RE: Butte Priority Soils Operable Unit (BPSOU) Revised Draft Final Insufficiently Reclaimed Sites Field Sampling Plans (FSPs) and Responses to Agency Comments

RE: Butte Priority Soils Operable Unit (BPSOU) Revised Draft Final Insufficiently Reclaimed Sites Field Sampling Plans (FSPs) and Responses to Agency Comments

Re: Butte Priority Soils Operable Unit (BPSOU) Revised Draft Final Insufficiently Reclaimed Sites Field Sampling Plan (FSP) BRES No. 34E – Eveline Dump East.

Figure 1 – Insufficiently Reclaimed Sites BRES No. 34E - Eveline Dump East Proposed Sample Stations

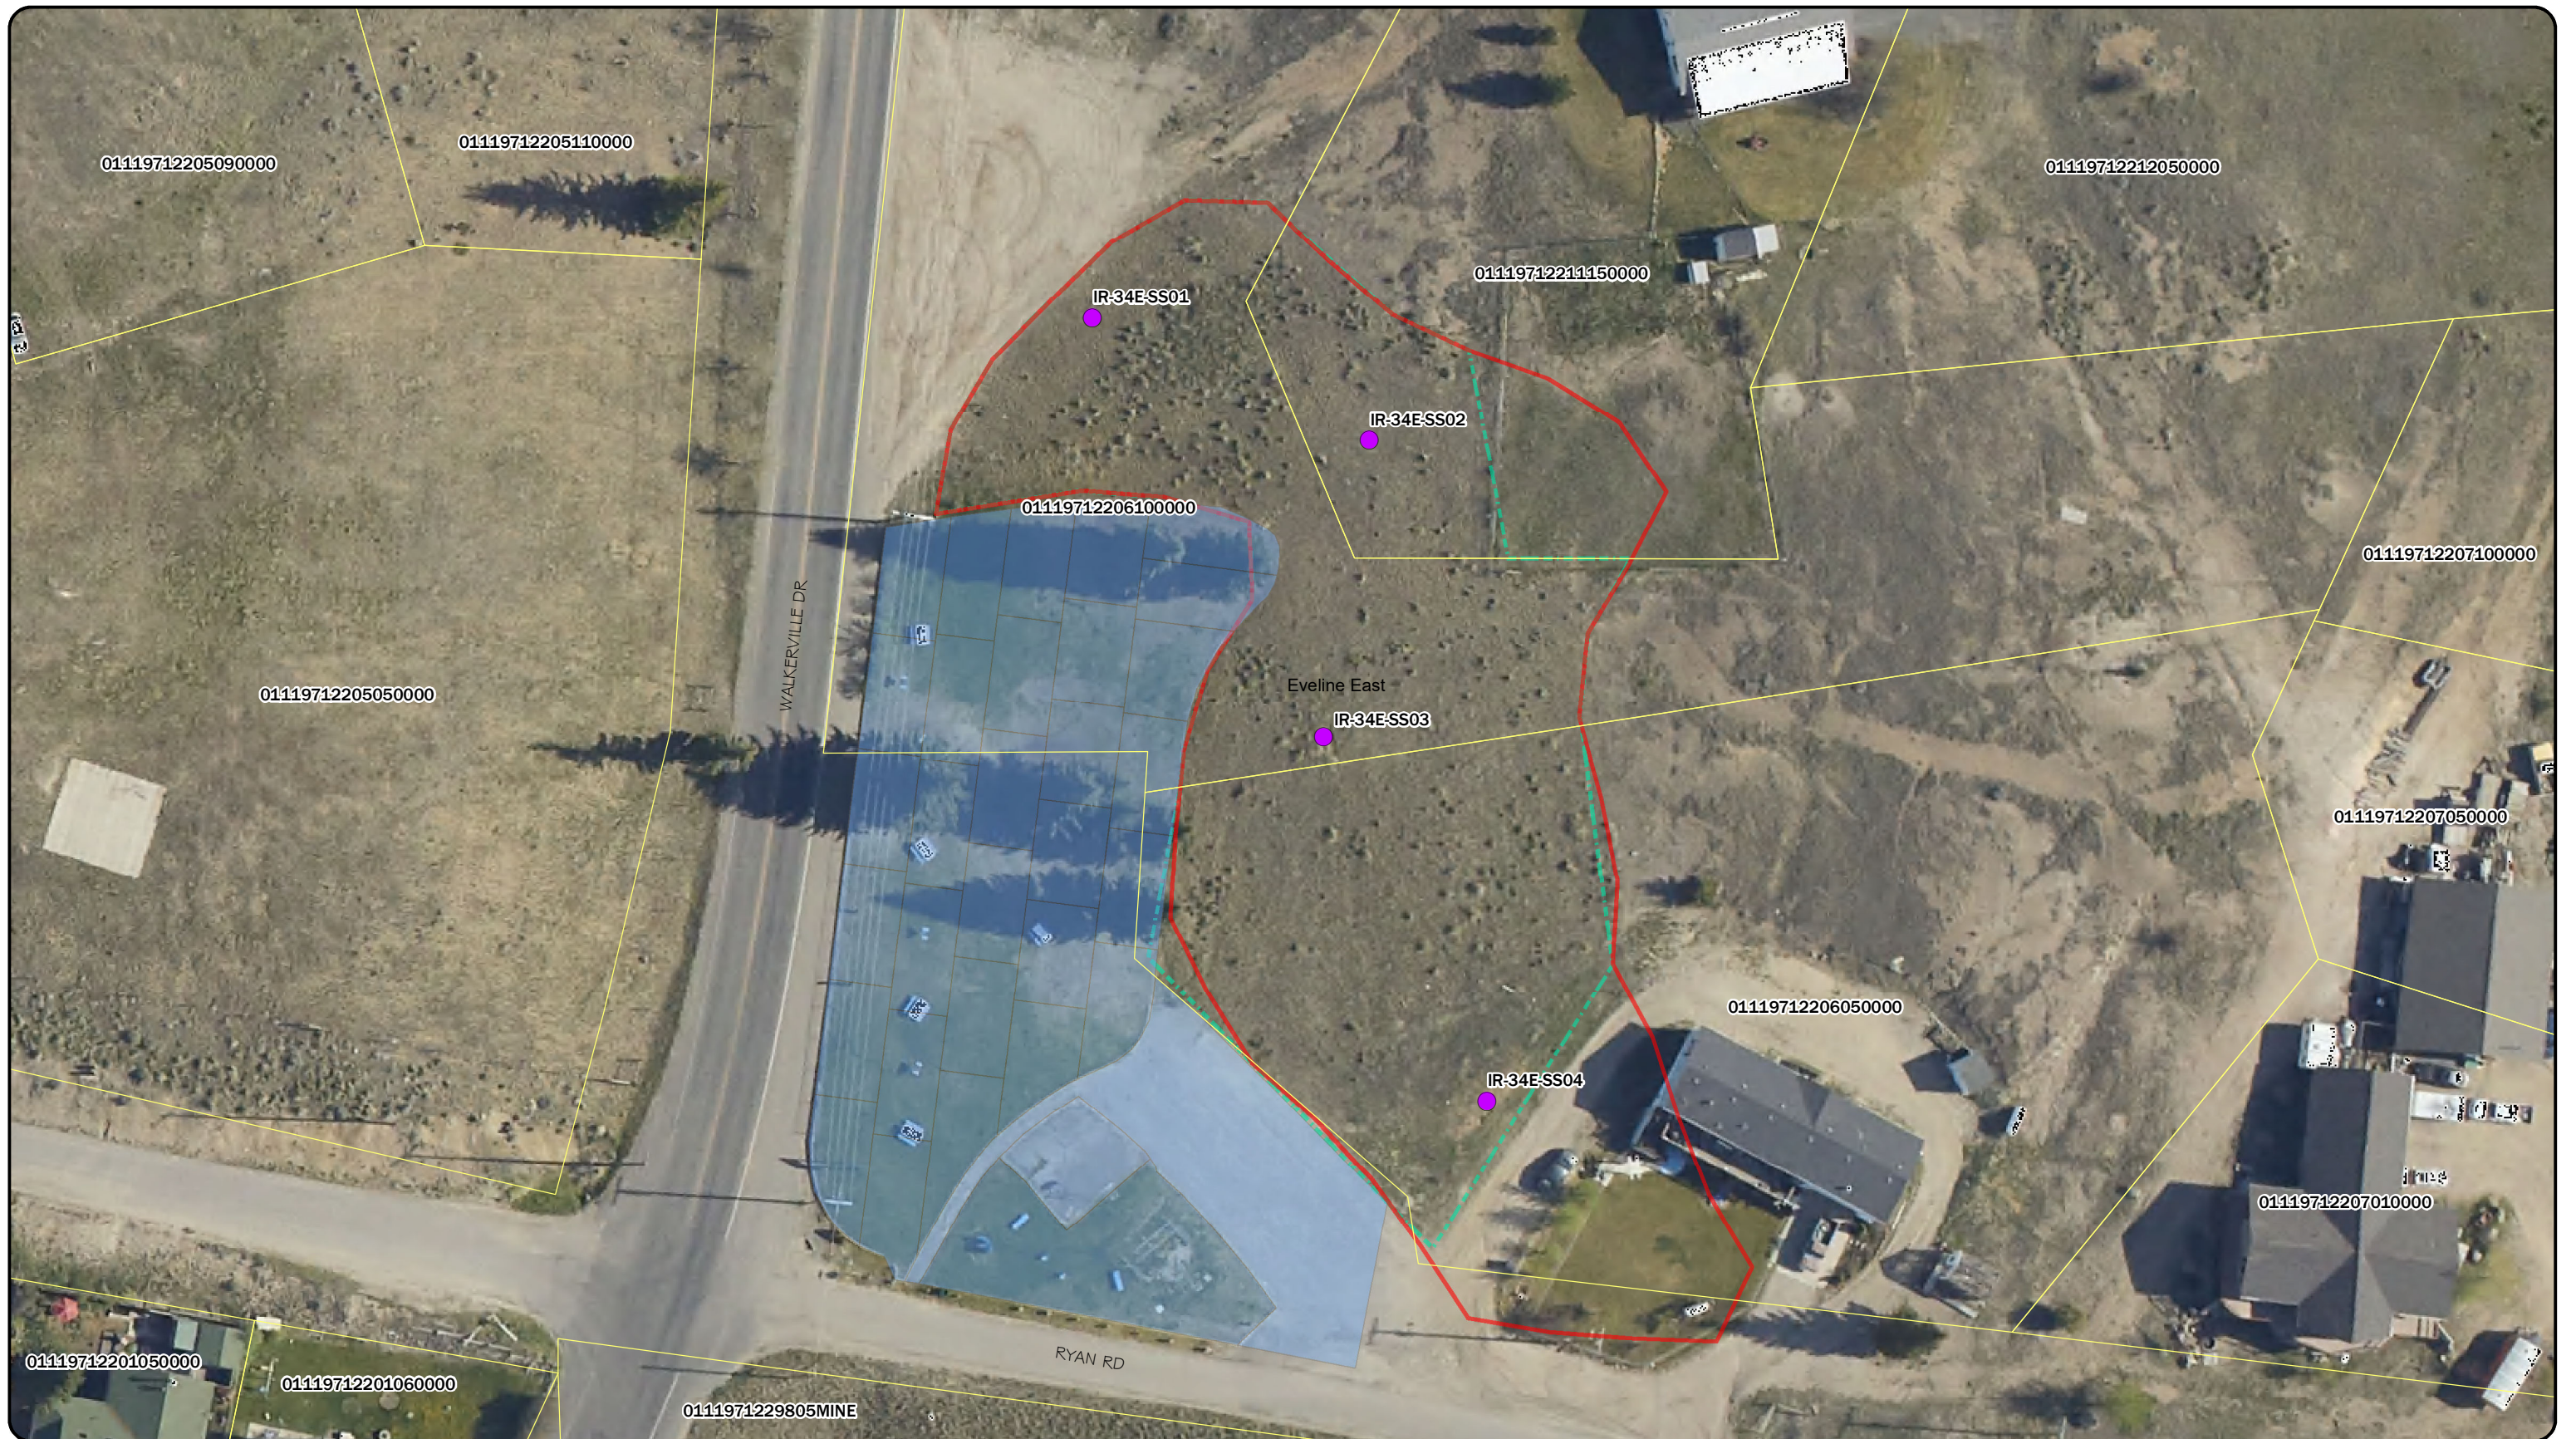
Agency Comment: *EPA has concerns about unilaterally transferring portions of BRES sites to the RMAP and transferring responsibility for cap maintenance to private property owners. Historic sampling at the Eveline (Site No. 34) to the east and Del Monte (Site No. 35) to the south have lead results exceeding 1,200 mg/kg. If similar concentrations of lead are present in the residential portion proposed for transfer to the RMAP, the thickness of any barriers to the waste is unknown and EPA is concerned*

that uncontrolled exposure could be occurring. With the BRES evaluations every four years, site conditions on the residential portion are at least being periodically checked and repairs implemented, if needed. Therefore, any boundary adjustments proposing to move a site or portion of a site from the BRES program to the RMAP program must be sampled and remediated, if necessary, before the BRES boundary adjustment can be considered. In the "Background" section of the FSP, please modify the third sentence of the last paragraph to read as follows: "Note that the Agencies have not approved the adjusted boundary and the adjustment may be made after RMAP sampling and remediation (if necessary) of the residential portion to be transferred is completed."

Atlantic Richfield Response: The requested edit has been included in the FSP.
